**RESOLUTION NO. 2025-036
VILLAGE OF CALEDONIA**

**A RESOLUTION APPROVING A CONCEPT PLAN FOR STORAGE SHOP USA COMMERCIAL
CONDOMINIUMS, APPROVING THE NET DENSITY OF 7.33 UNITS PER ACRE, APPROVING
WAIVERS TO ORDINANCE SEC. 14-3-4(c)(4)(b)(ii), 14-3-5(b), AND AUTHORIZING THE
COMBINATION OF THE PRELIMINARY AND FINAL PLAT STAGE FOR REVIEW AT 7930 E.
FRONTAGE ROAD.**

Re: **Concept Condominium Plat – Storage Shop USA – 7930 E. Frontage Road**
Parcel ID 104-04-22-07-053-000
Applicant & Owner – Greg Thomas – Storage Shop USA

A CONDOMINIUM PLAT

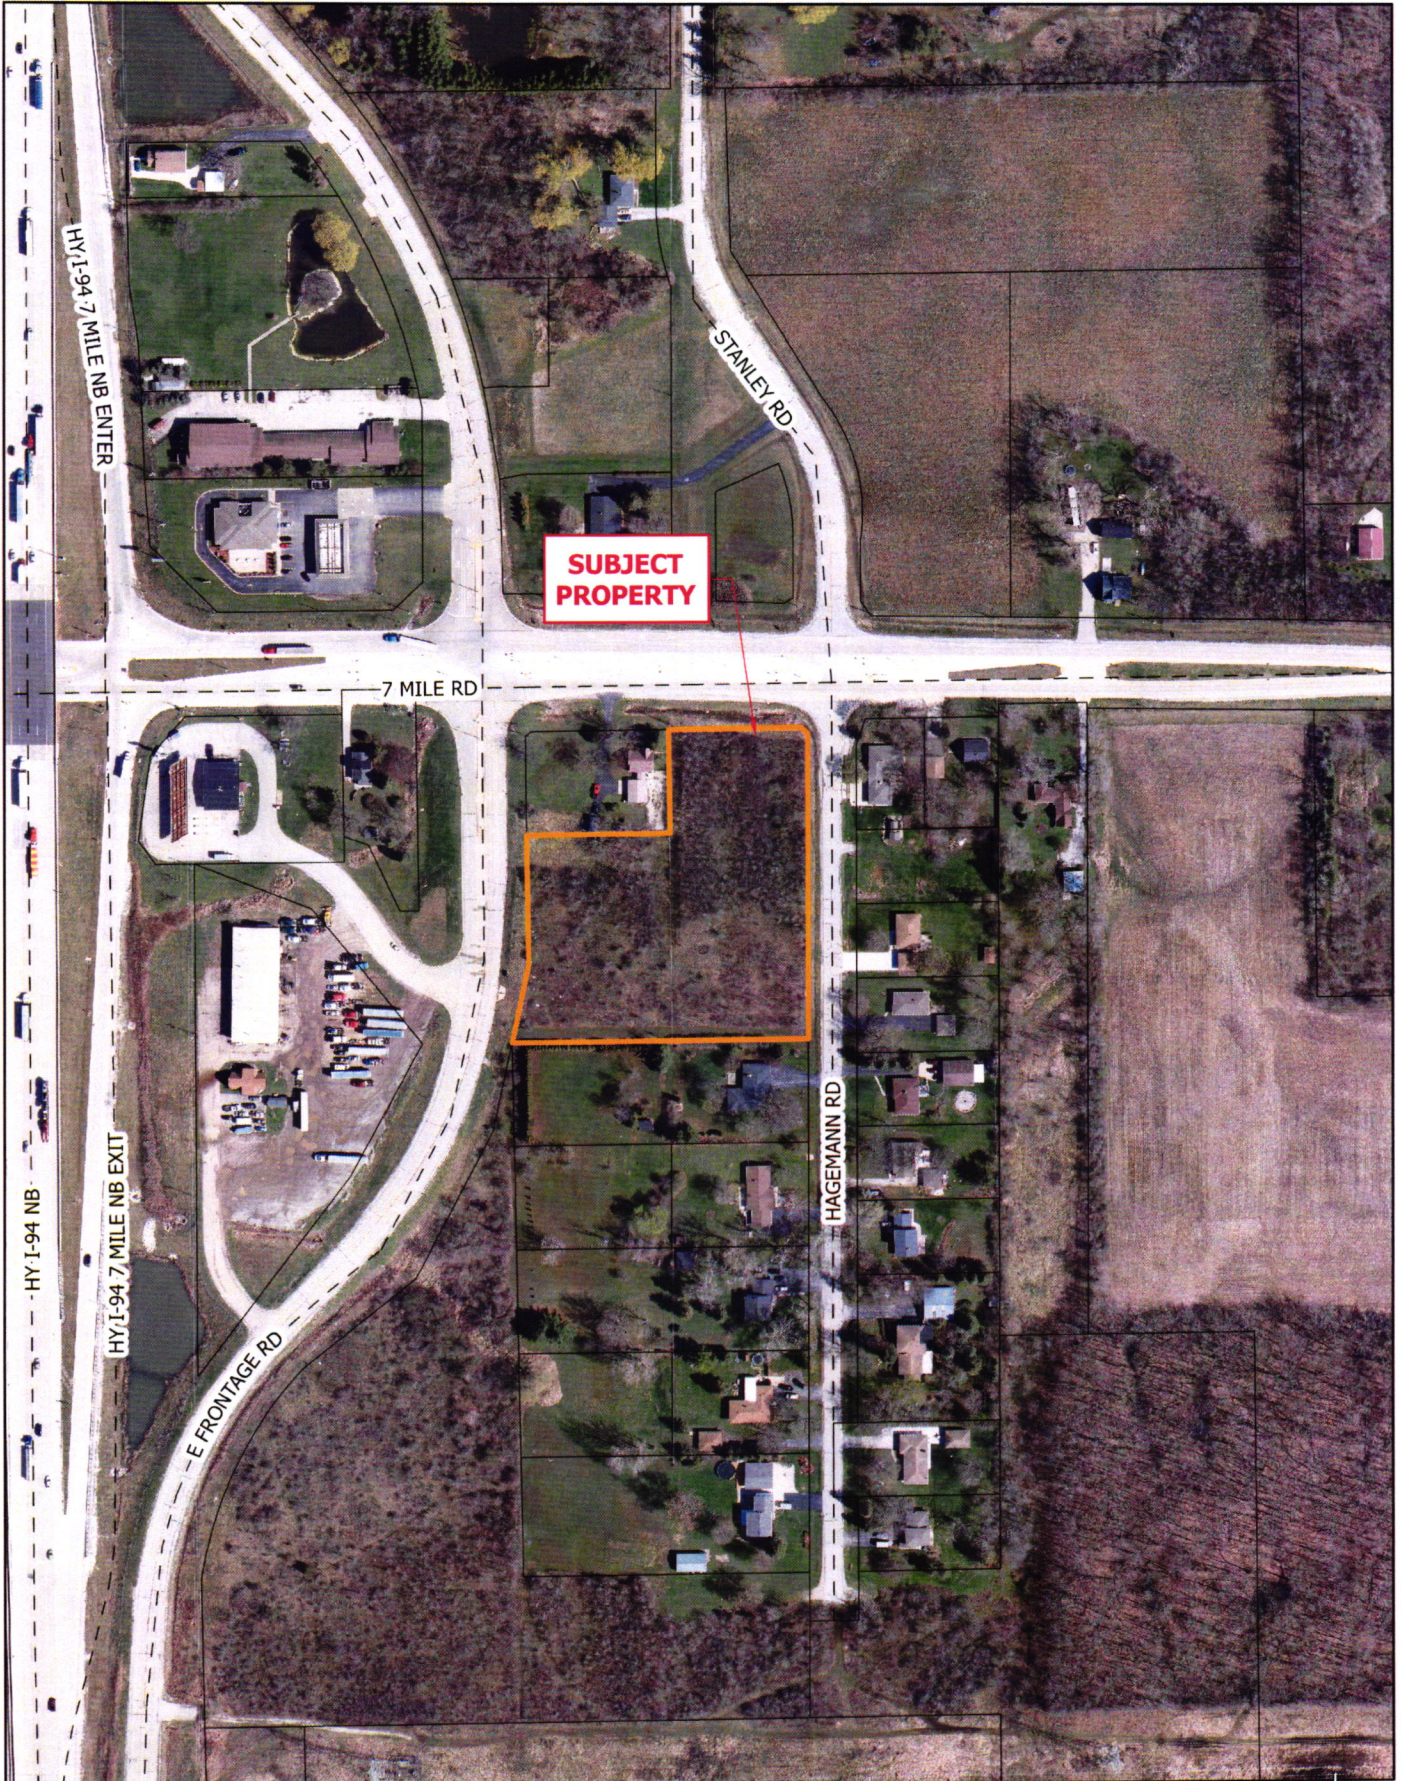
As described in the beginning of this memorandum, a set of civil engineering plans and a Storm Water Management Plan have been reviewed and approved by Staff. The Owner has applied for a Land Disturbance permit and acquired a DNR WPDES General Permit. There are two storm water ponds proposed for the site that are required to have storm water easements over them. These shall be shown on the Final Plat and executed with an easement agreement separately with the Village of Caledonia and Utility District.

5. Owner/Developer shall update the plat to show the proposed Storm Water Pond Easements and record the easement document and agreement separately with the Village of Caledonia Utility District.

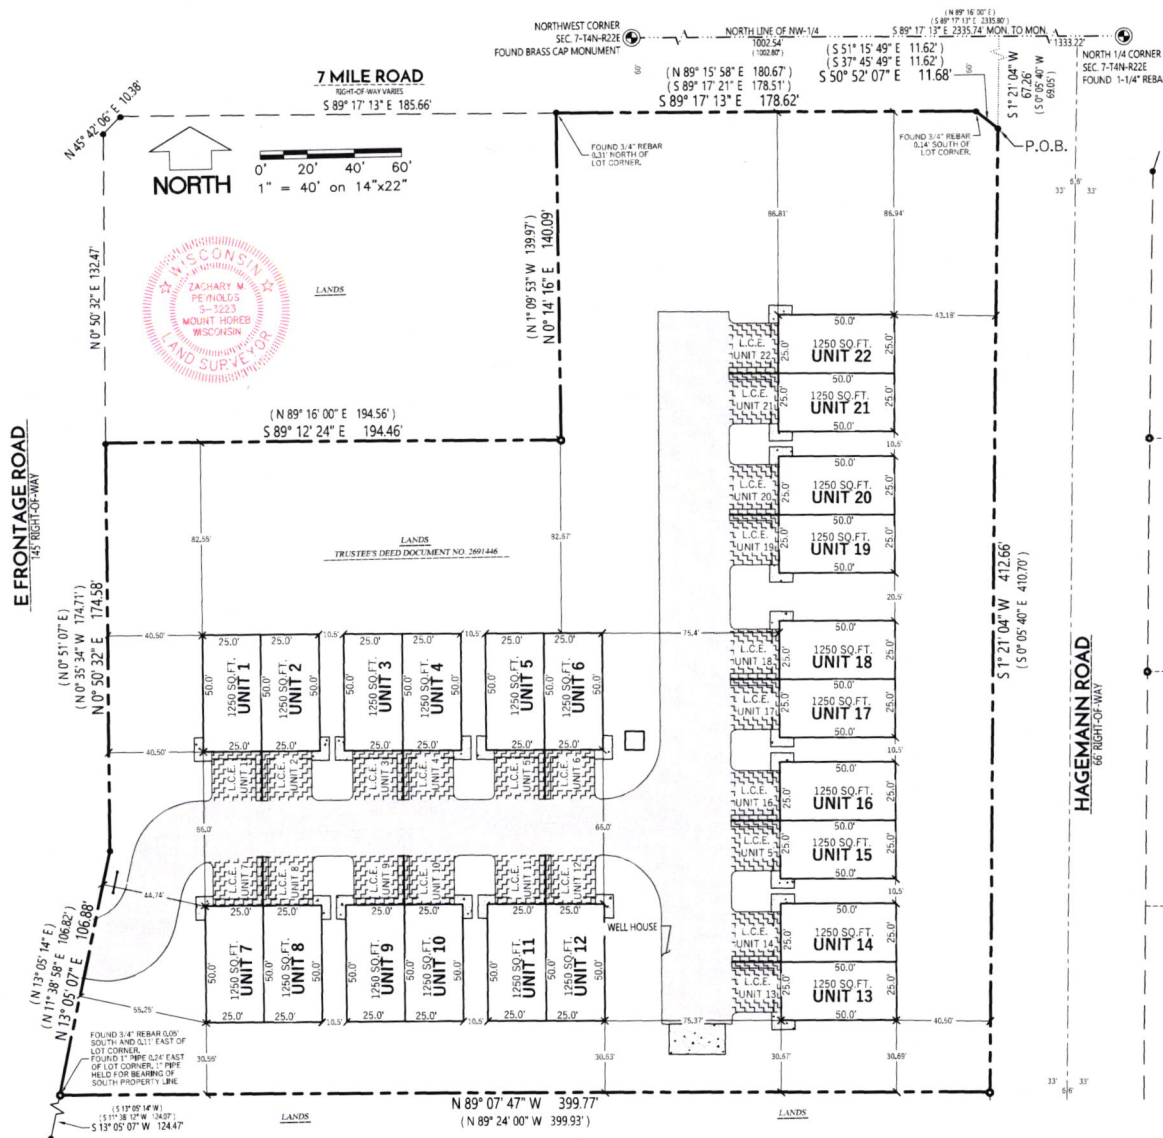
No access restriction shall be placed and shown along 7 Mile Road, the Northeast corner of the property, and Hagemann Road. It is recommended that No Access be placed in conjunction with the Wisconsin DOT along the E. Frontage Road as well, but this area is outside of Village Jurisdiction. In addition to the no access, a 25'x25' vision triangle shall be placed at the NE corner of the property.

The proposed commercial Condo Plat as presented shows multiple bearings with 2 corrective or alternative bearing angles and distances. Staff would like clarity on these bearings and to ensure the appropriate legal description of the property is being used to ensure no legal gaps are created as part of this Condo Plat. The coordinates shall also be placed on the Condo Plat for the Quarter Sections being referenced. Lastly, there is a minor error with the misplacement of the well house label that should be corrected along with a typing error in the surveyor's certificate calling out the "StorageSuiteUSA" rather than the StorageShopUSA being referred to.

8. Surveyor to update the Condo Plat to show No Access along 7 Mile Road, Hagemann Road, and the E. Frontage Road as required by the WisDOT.
9. Surveyor to update the Condo Plat to show a 25'x25' Vision Triangle at the NE corner of the property.

10. Surveyor to Update the Condo Plat to include coordinates of the Section Corners and to clarify or correct the measurements provided for the bearings and distance measurements for this property.

11. Surveyor to update the Condo Plat to provide the corrections on the well house label and errors in the surveyor's certificate.
12. Owner/Developer to execute and record the Village approved revision of the declaration documents for the condominium in conjunction with the recording of the Final Plat.
